J. E. STOVER & ASSOCIATES, INC.

November 29, 2018

Re: Bowie Resources, LLC, Bowie No. 1 Mine
TR-64, East Roatcap Creek Culvert Removal – Reclamation Plan
Adequacy Response #1
Permit C-1981-038

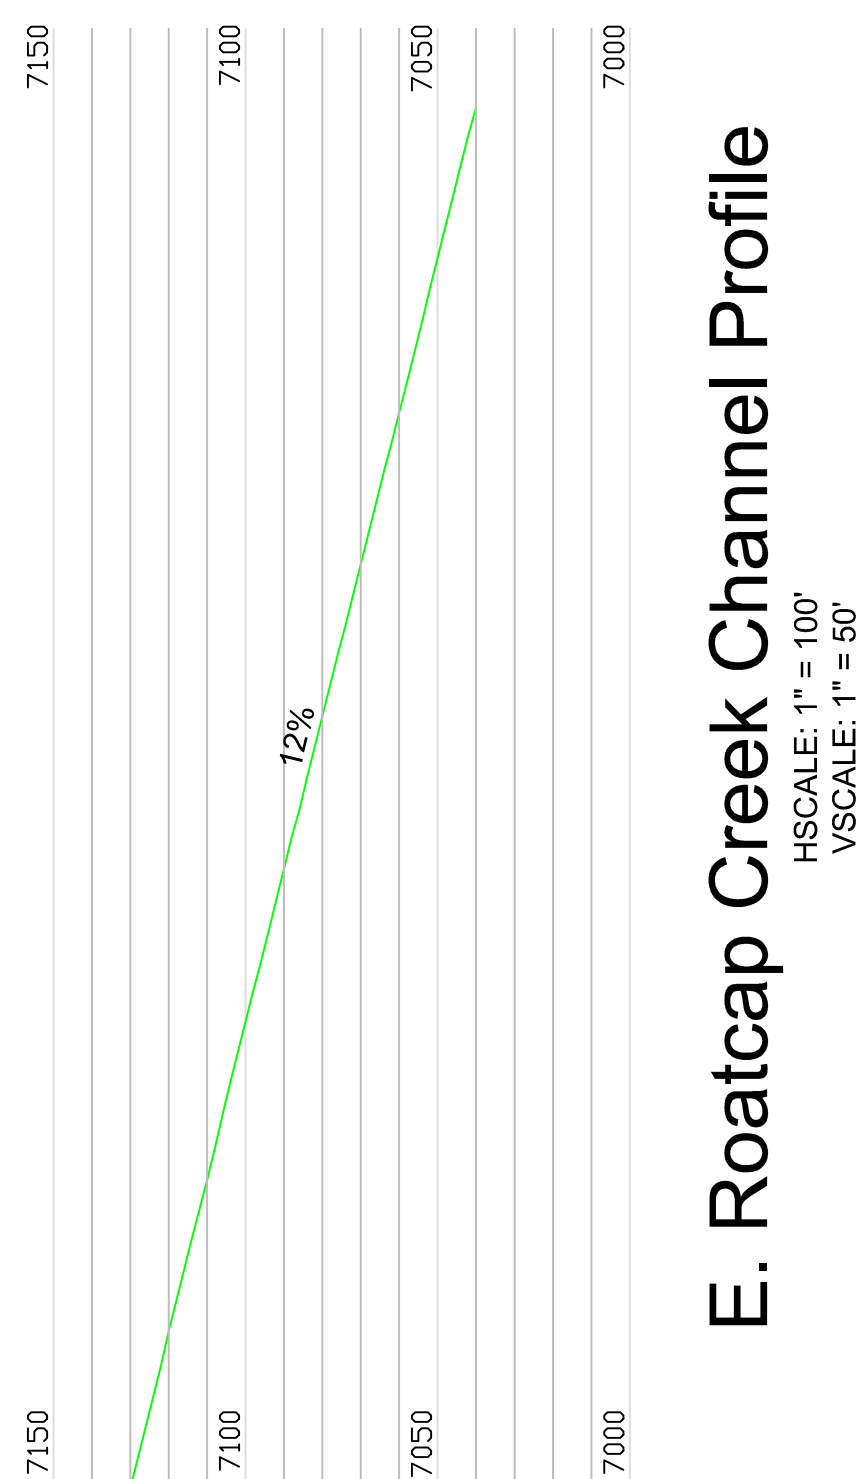
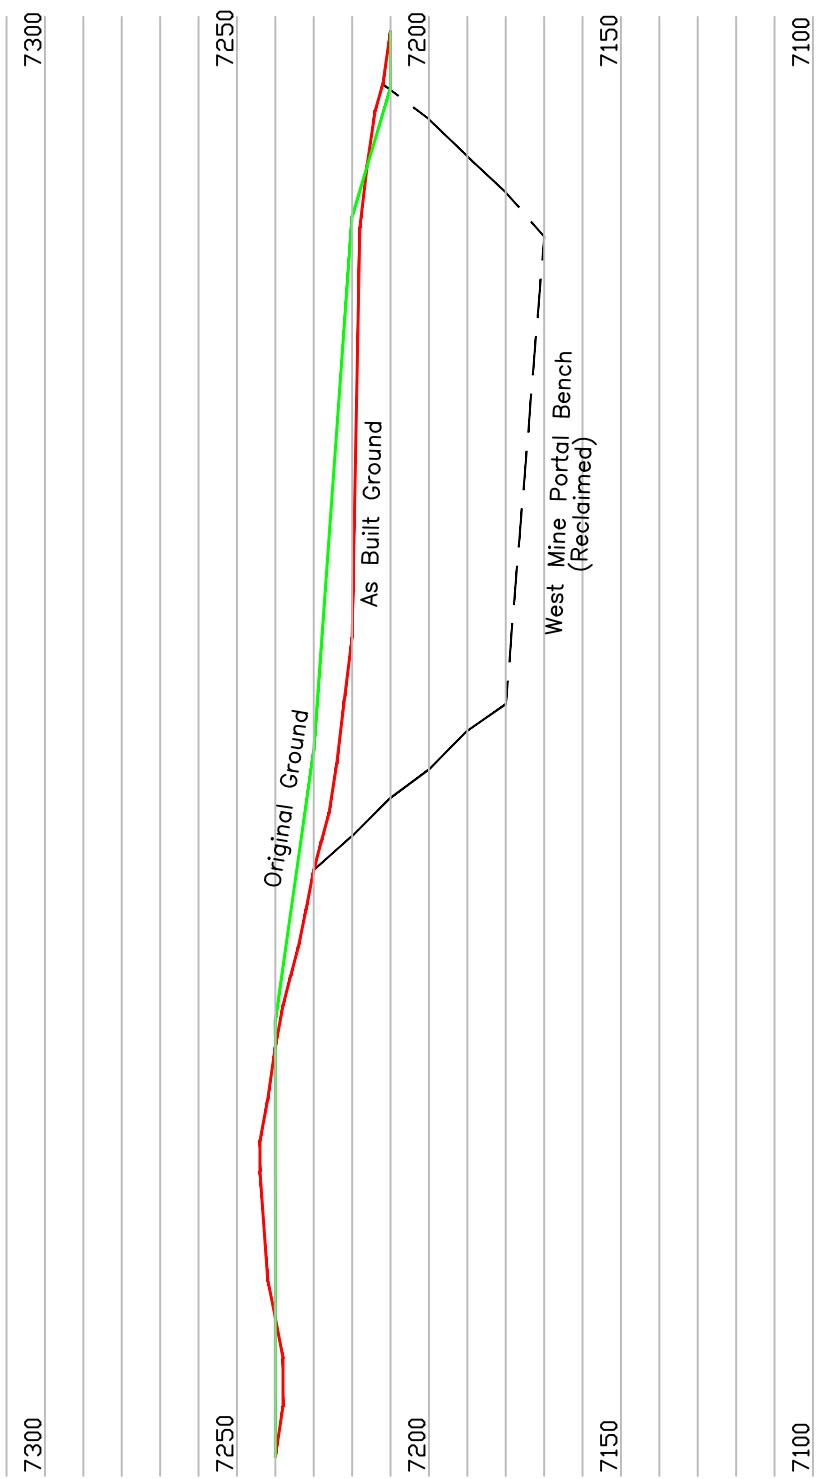
2. **DRMS:** It is unclear why map 8A-19, which indicates post-mining conditions, includes structures that will be removed, per the proposed revisions. These structures include W-1 & W-2 on the plan view as well as Pond W-1 and the culvert on Section A-A'. Please revise the map or explain why these structures are left on the map.

3. **DRMS:** Please provide a longitudinal profile of the reconstructed East Roatcap Creek.

BRL: Please see revised **Map 8A-19**.

BRL: Please see the channel profile on **Map 8A-19**.
